**Eastonville Road – Londonderry Drive to Rex Road
Segment 1 Improvements
Stationing 14+19.69 – 47+66.51**

Final Drainage Report

August 2024

EDARP File No.: CDR2321

DETENTION BASIN STAGE-STORAGE TABLE BUILDER

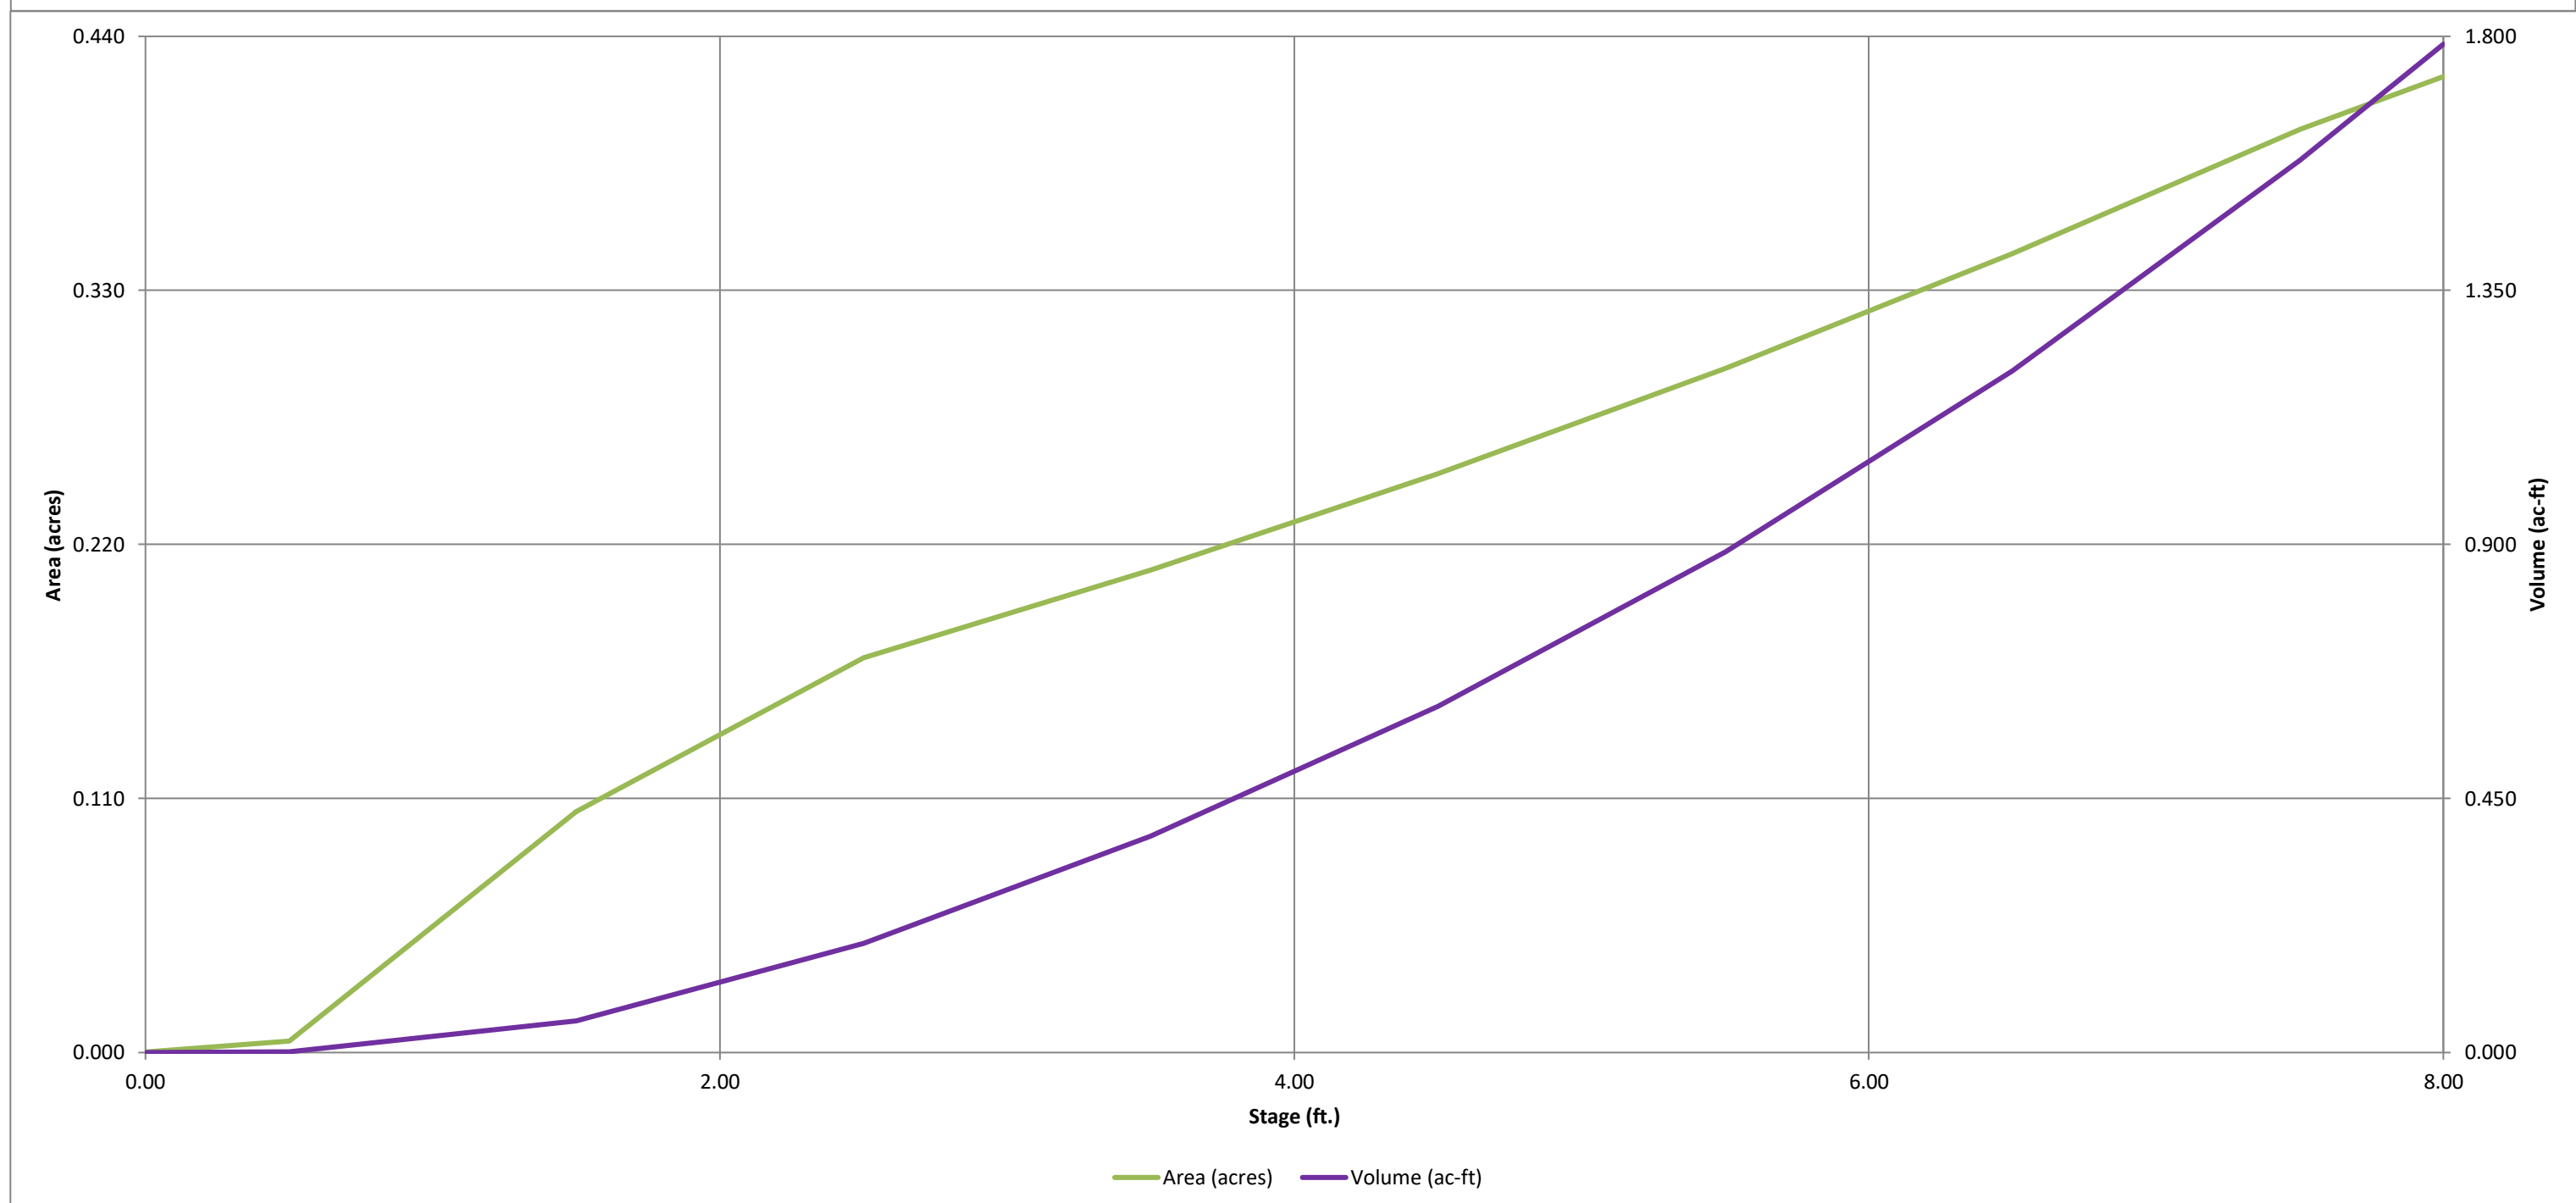
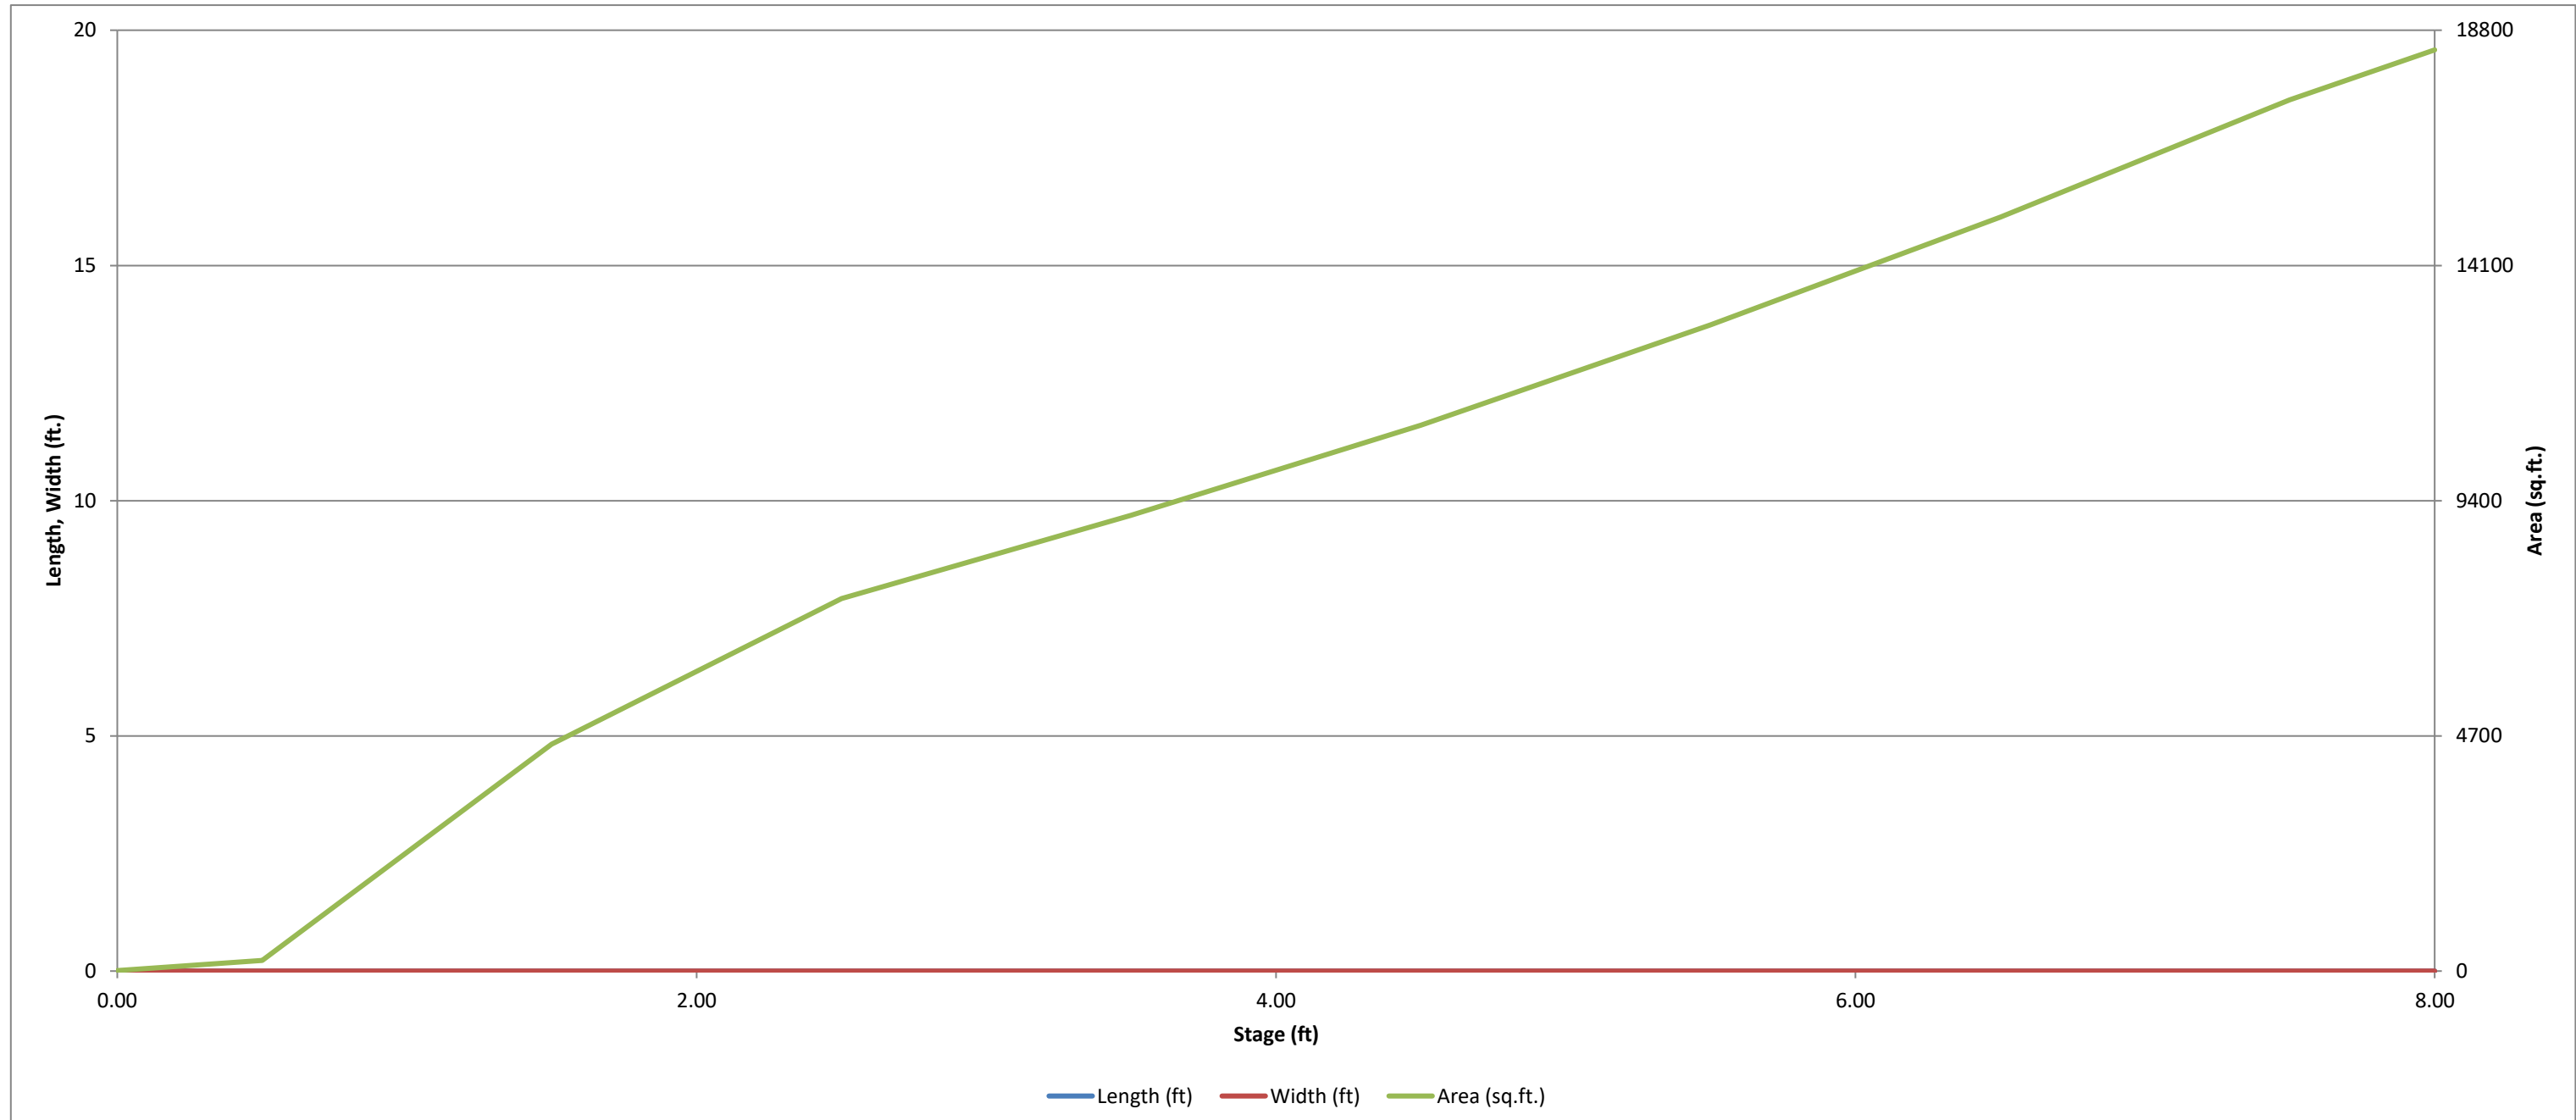
When are the details for this Ultimate Condition going to be designed/submitted? Because I do not see them with the Segment 2 CDs.

Please provide them so that I can review these calcs.
